UNITED STATES
NUCLEAR REGULATORY COMMISSION
WASHINGTON, D. C. 20545

The Commission has issued the enclosed Amendments Nos. 74 and 73 to Facility Operating Licenses Nos. DPR-44 and DPR-56 for the Peach Bottom Atomic Power Station, Units Nos. 2 and 3. These amendments consist of changes to the Technical Specifications (TSs) in response to your application dated September 15, 1980.

AMENDMENT TO FACILITY OPERATING LICENSE

Amendment No. 74
License No. DPR-44

Figure 6.2-2

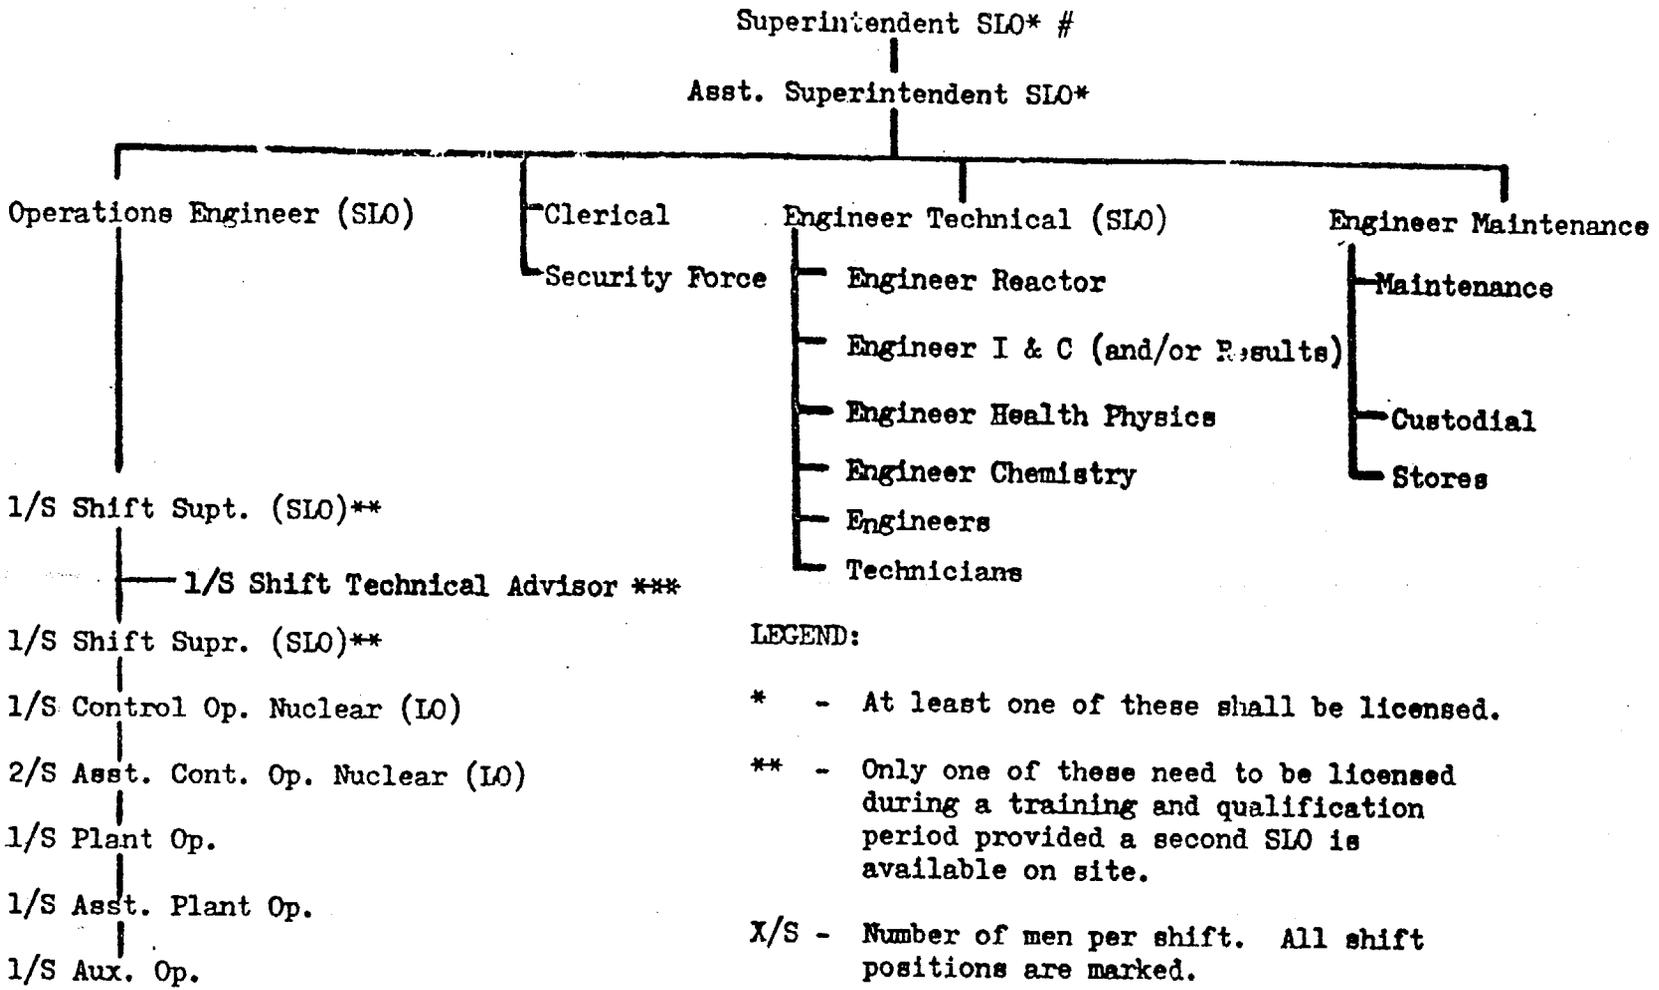
Our request indicated that the TSs related to minimum shift manning should be revised to reflect the augmentation of a STA. The licensee's application would add one STA to each shift to perform the function of accident assessment. The individual performing this function will have at least a bachelor's degree or equivalent in a scientific or engineering discipline with special training in plant design, and response and analysis of the plant for transients and accidents. Part of the STA duties are related to operating experience review function. Based on our review, we find the licensee's submittal to satisfy our requirements and is acceptable.

6.3.1 Each member of the facility staff shall meet or exceed the minimum qualifications of ANSI N18.1-1971 for comparable positions, except for (1) the Engineer-Health Physics who shall meet or exceed the qualifications of Regulatory Guide 1.8, September 1975 and (2) the Shift Technical Advisor who shall have a bachelor's degree or equivalent in a scientific or engineering discipline with specific training in plant design, and response and analysis of the plant for transients and accidents.
